**HOW A COMBINED HEAT AND POWER (CHP) PLANT SHOULD WORK:** It puts out USABLE heat , AND usable electricity...AND IS QUITE EFFICIENT

**BIOPOWER 5** IS THE UNIT PLANNED - Look at the efficiency..

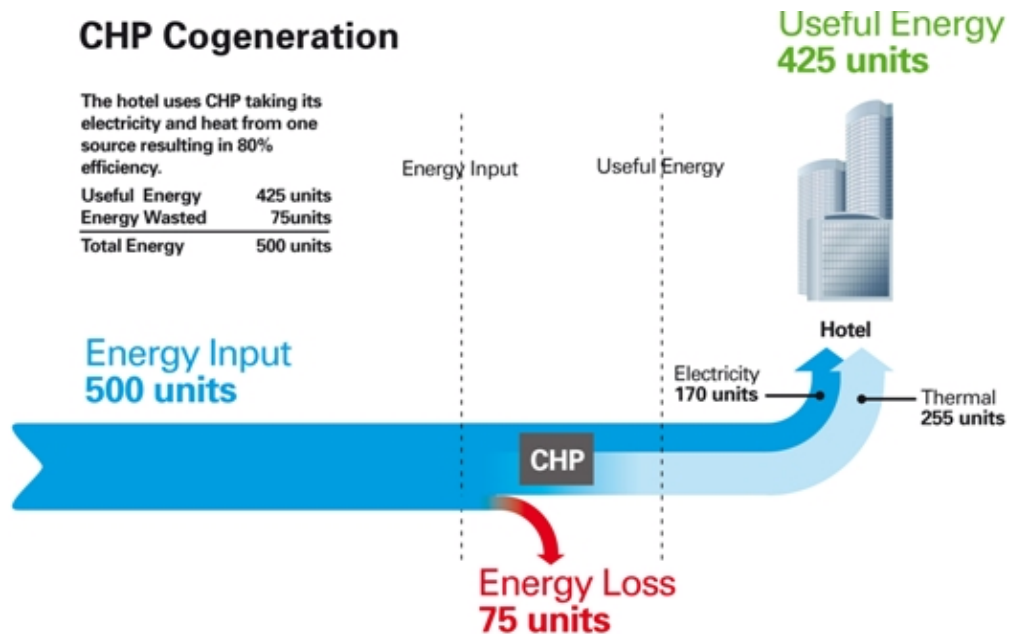
BUT THAT IS **NOT WHAT IS PROPOSED**...Although it is described loosely as CHP, it is NOT a CHP plant. Articles in the press quote NEDL as saying it would "heat and light 10,000 homes" It will not do that - 4.5 MWe would be sent out of the plant - that would supply electricity only - no heat - to about 8000 homes. If you want to heat the homes as well from this plant, the number is less than half that.
